# Memorandum

**Subject: REVISION TO CUMULATIVE IMPACTS FIGURE 1 AS REFERENCED BY VISUAL RESOURCES STAFF - IVANPAH SOLAR ELECTRIC GENERATING SYSTEM (07-AFC-5) Exhibit 308**

APPLICATION FOR CERTIFICATION  
FOR THE *IVANPAH SOLAR ELECTRIC  
GENERATING SYSTEM*

# Cumulative Impacts - Figure 1

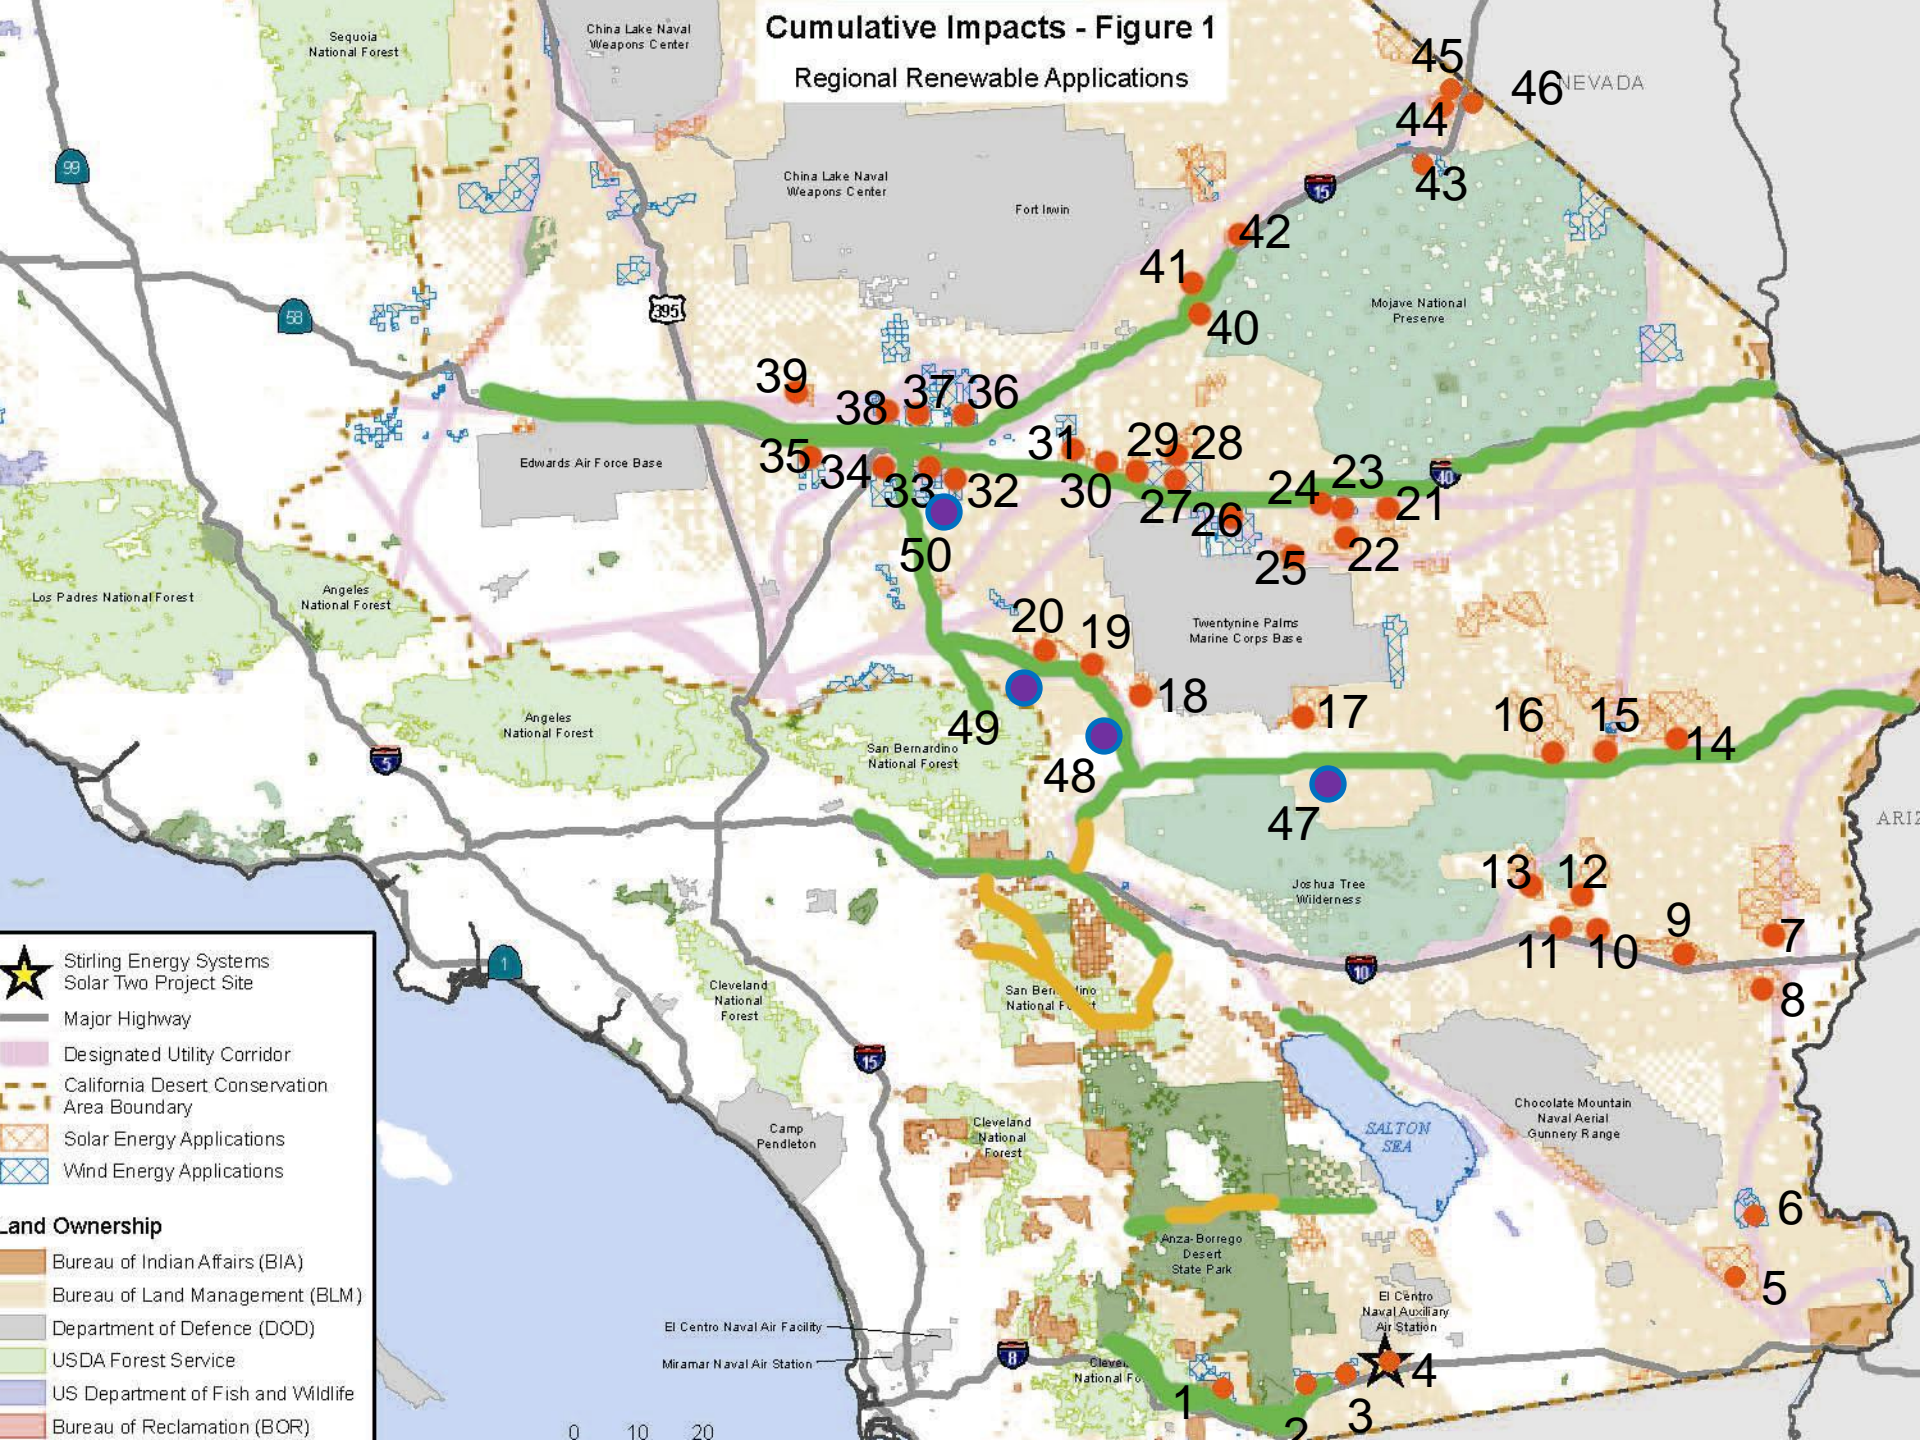
Energy Commission staff is providing a revision to Cumulative Impacts – Figure 1 as requested by the applicant to identify the names of foreseeable renewable energy projects that had previously been identified only by location. Figure 1 was previously distributed on December 14, 2009 as included in staff’s Exhibit 301 showing Visual Resource photos.

\*\*\* Purple dots indicate **new** projects along US highways not identified in **Cumulative Impacts – Figure 1** but shown in current listing: BLM CDD Renewable Energy Projects and Utility Corridors (November 2009).
